26 May 2015

DA 1031/15 - Proposed Subdivision at Lot 198 DP 1191172, Lot 98 DP 1165173, 1452 Solitary Islands Way, Sandy Beach
Response to Council's Request for Additional Information

AV Jennings Properties Ltd
Stages 3-6, Sandy Beach Subdivision
Stormwater Management Report

Client AV JENNINGS PTY LTD
Project SANDY BEACH SUBDIVISION STAGE 3
Title INDICATIVE SEDIMENT AND EROSION
CONTROL PLAN

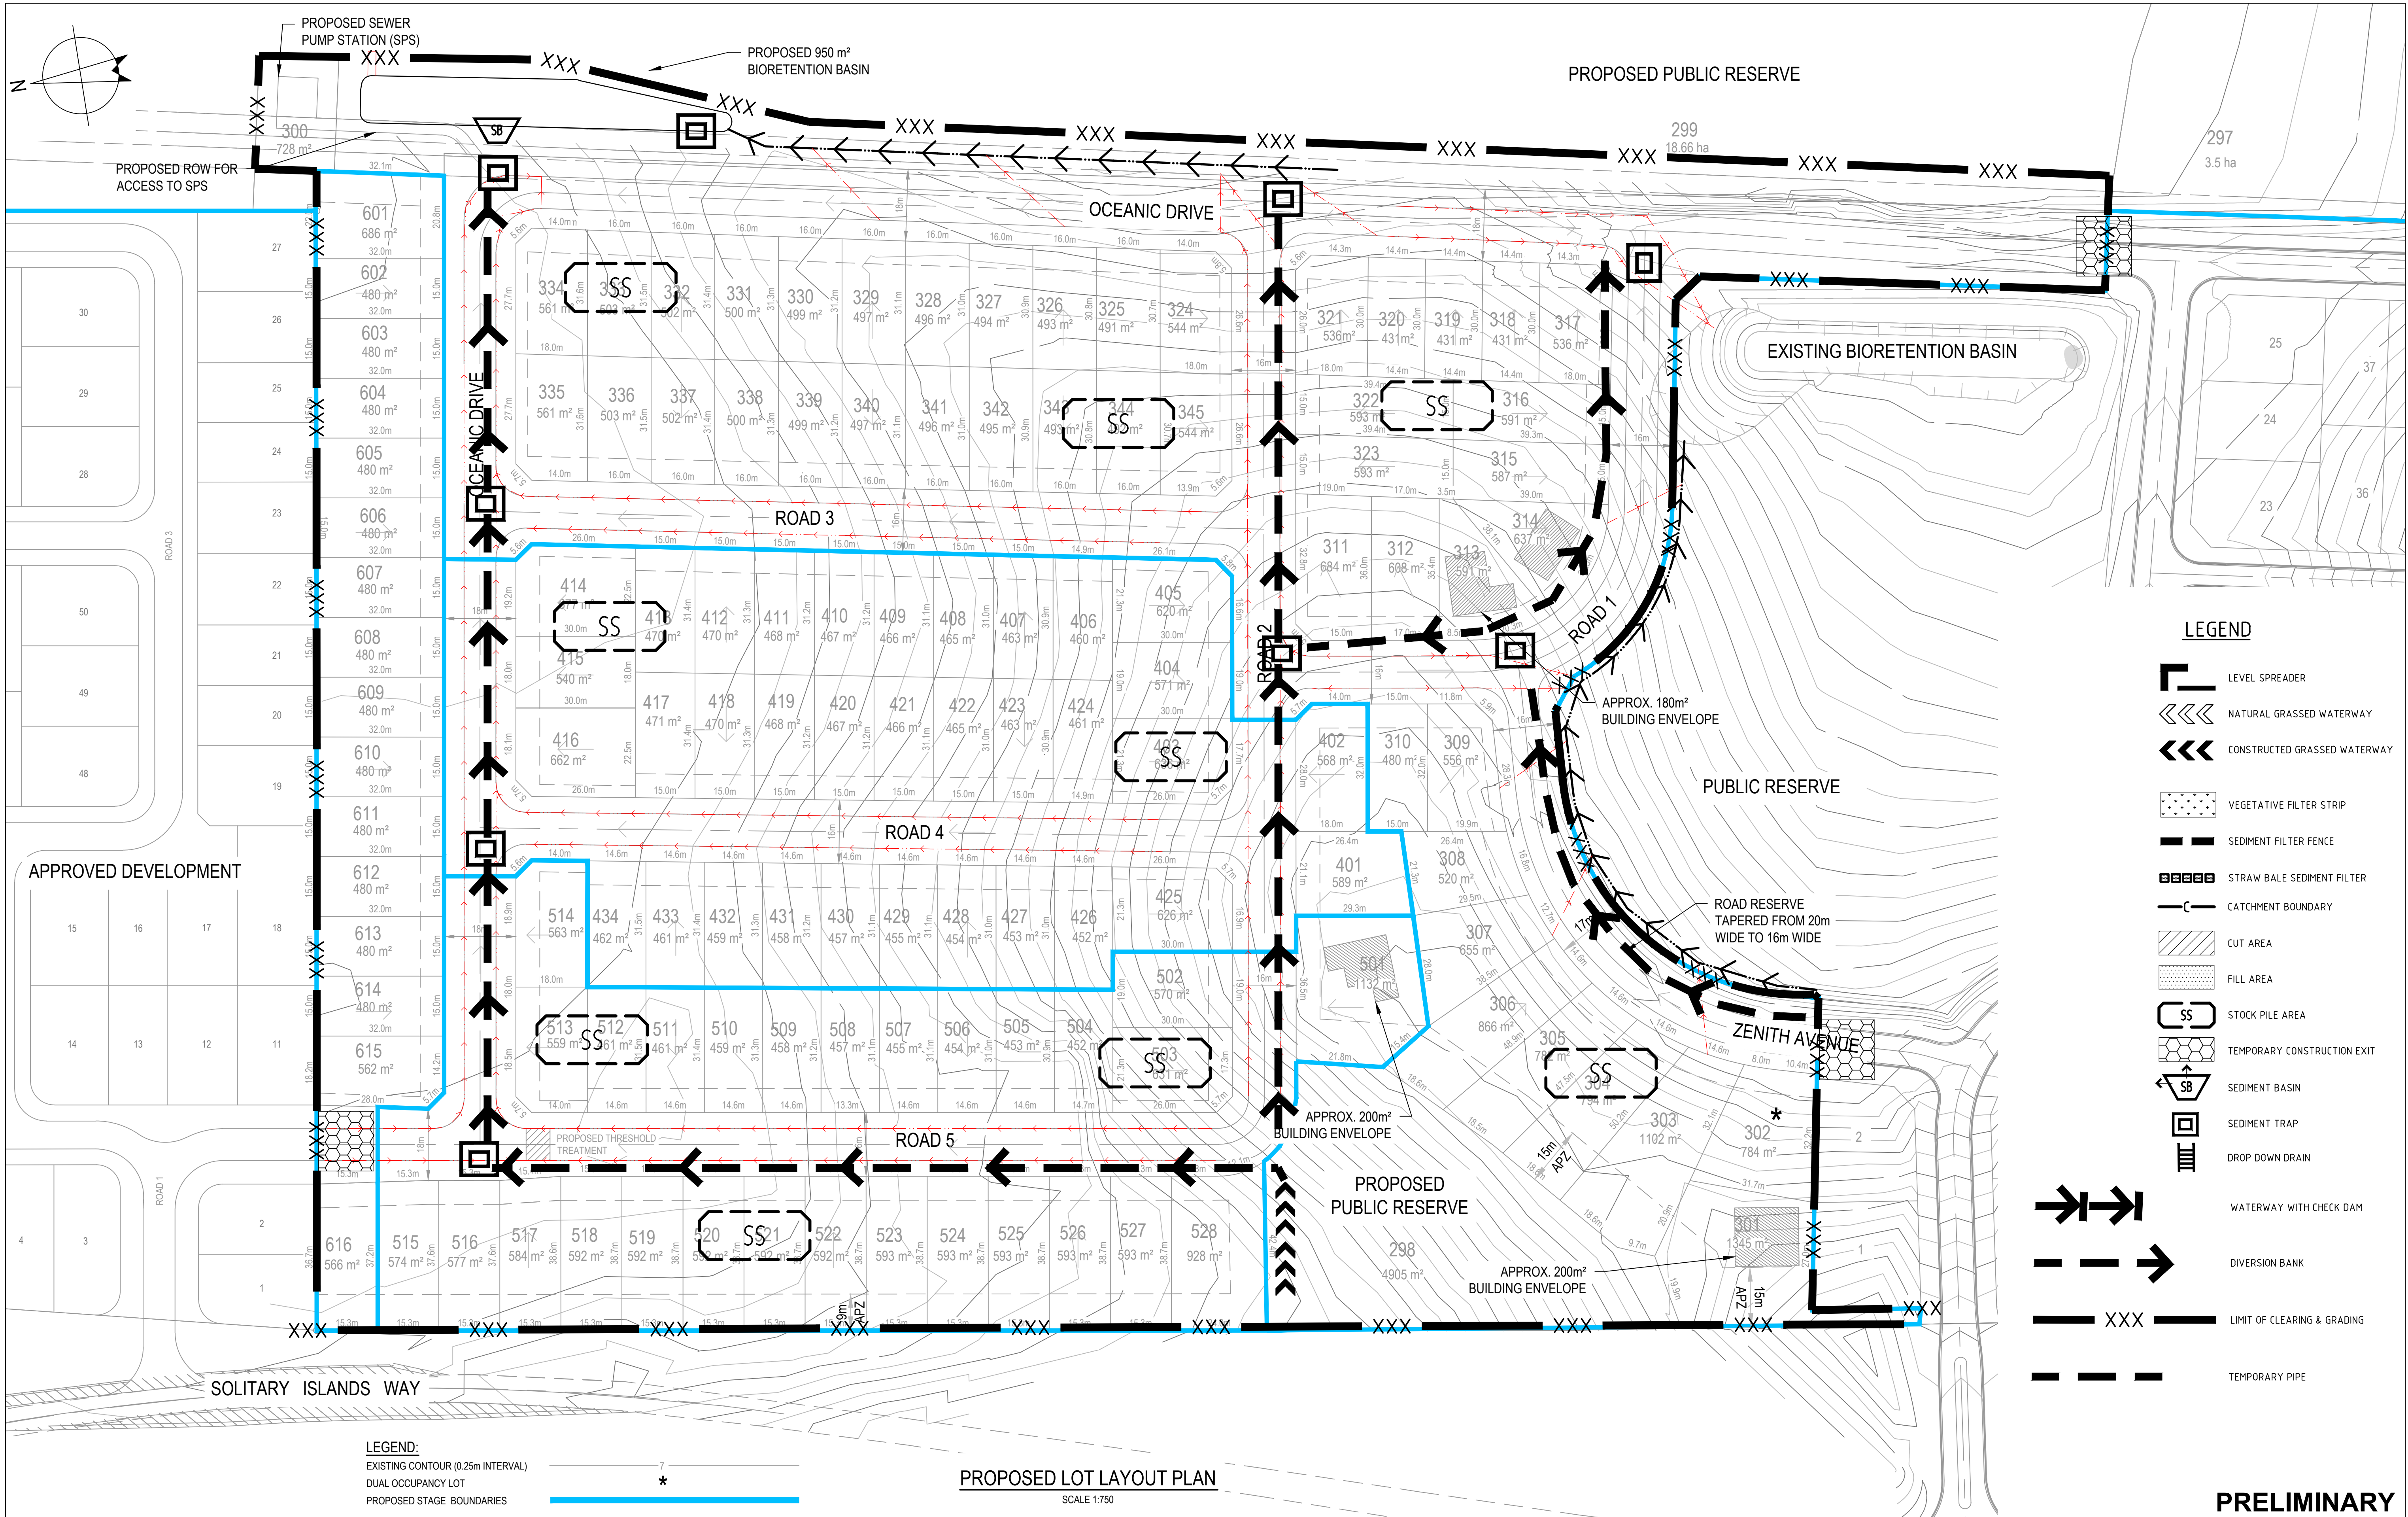
An indicative sediment and erosion control plan has been prepared and is attached to this letter.

| | | | | | | | |  <div>230 Harbour Drive Coffs Harbour NSW 2450 Australia T 61 2 6650 5600 F 61 2 6650 5601 E cfsmail@ghd.com W www.ghd.com</div> | DO NOT SCALE | | Drawn I. GOULD | Designer | Client Project | AV JENNINGS PTY LTD SANDY BEACH SUBDIVISION STAGE 3 ASSET PROTECTION ZONES | |

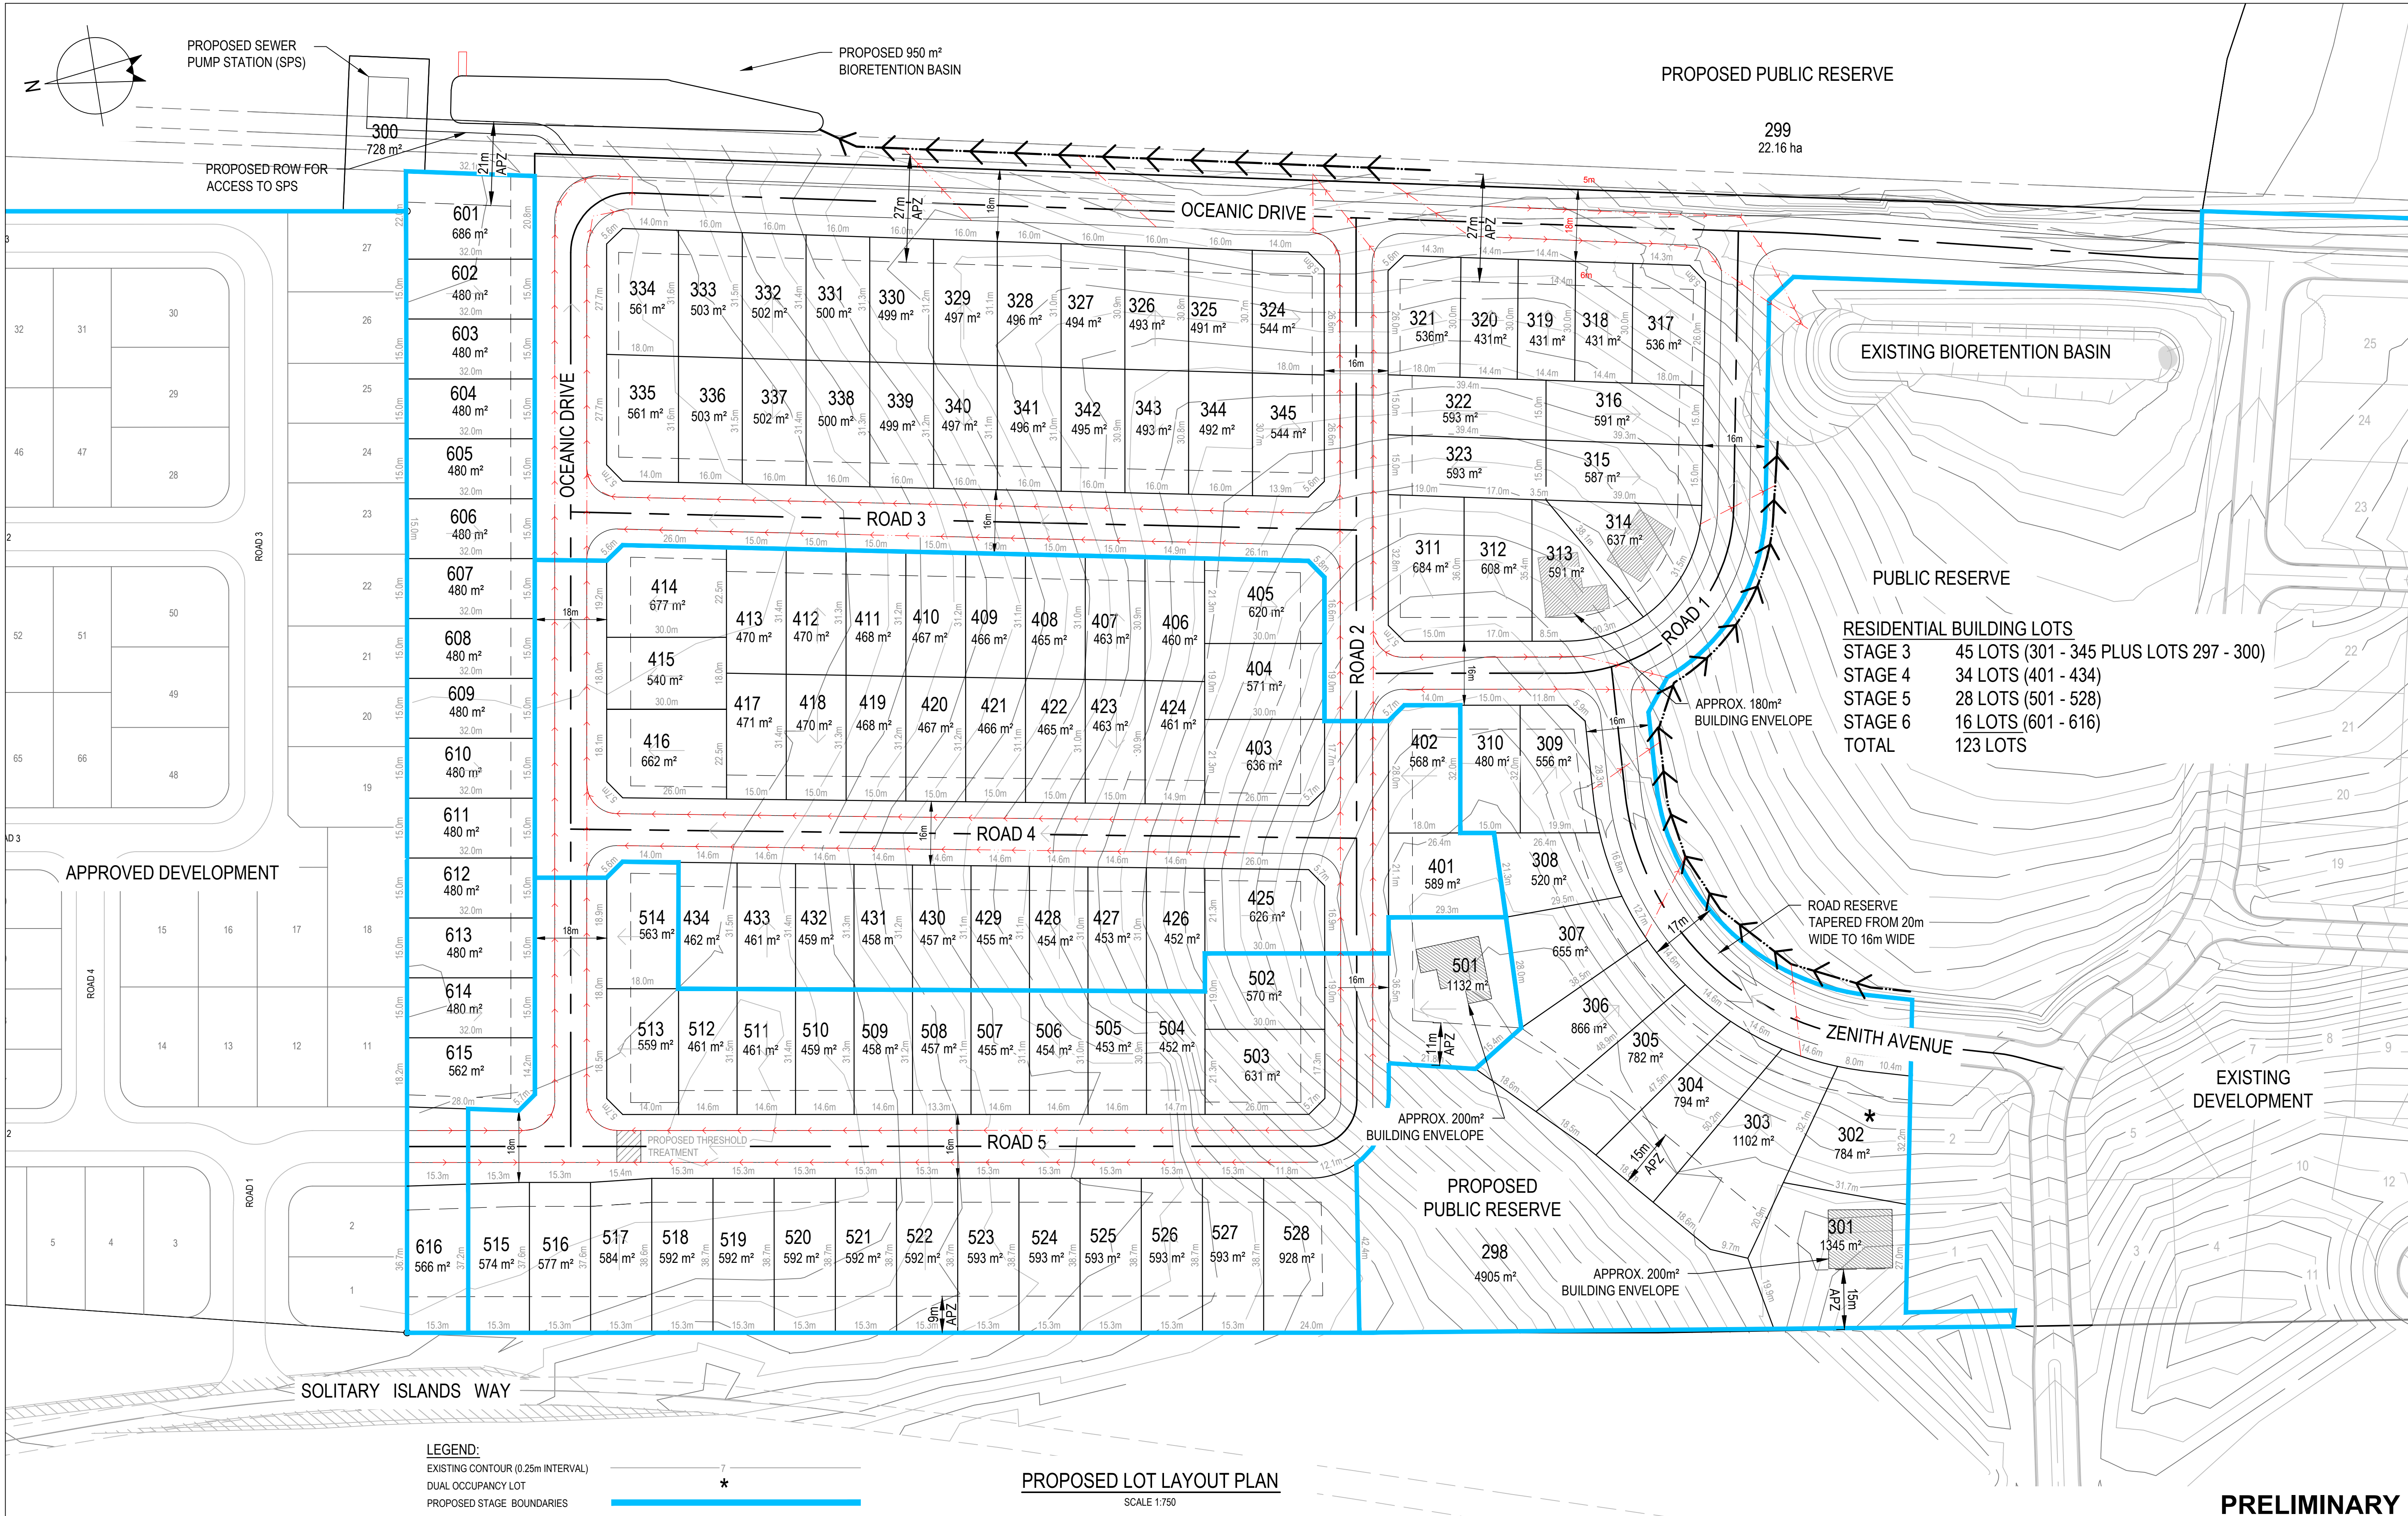
Reference is made to NSW RFS letter dated 13 August 2014 requesting additional information in relation to the asset protection zones along the eastern interface of the proposed subdivision with the proposed environmental zoned land (likely to be E2 under Coffs LEP 2013).

In relation to proposed Lots 317 – 331, an APZ of 27 metres is required in accordance with AS 3959 2009. The required APZ is achieved as a result of an existing 5 metre wide water supply easement, a road reserve width of 18 metre and variable together with a 6 metre wide front building line setback and a proposed bio-retention swale (see dimensions in red). By virtue of the positioning of the easement and the need to maintain access in perpetuity, the required APZ can be sufficiently achieved.

In relation to proposed Lots 332 – 334 and Lot 601, an APZ of 21 metres is required in accordance with AS 3959 2009. The required APZ is achieved as a result of a proposed bioretention basin and access track to provide access to the proposed sewer pump station to be constructed to service both the proposed subdivision and the adjoining subdivision to the north. The access track would sit over the existing 5 metre wide water supply easement and below the existing overhead power line in this location. By virtue of the positioning of the easement and the need to maintain access in perpetuity, the required APZ can be sufficiently achieved. The DP shows the location of the water easements.
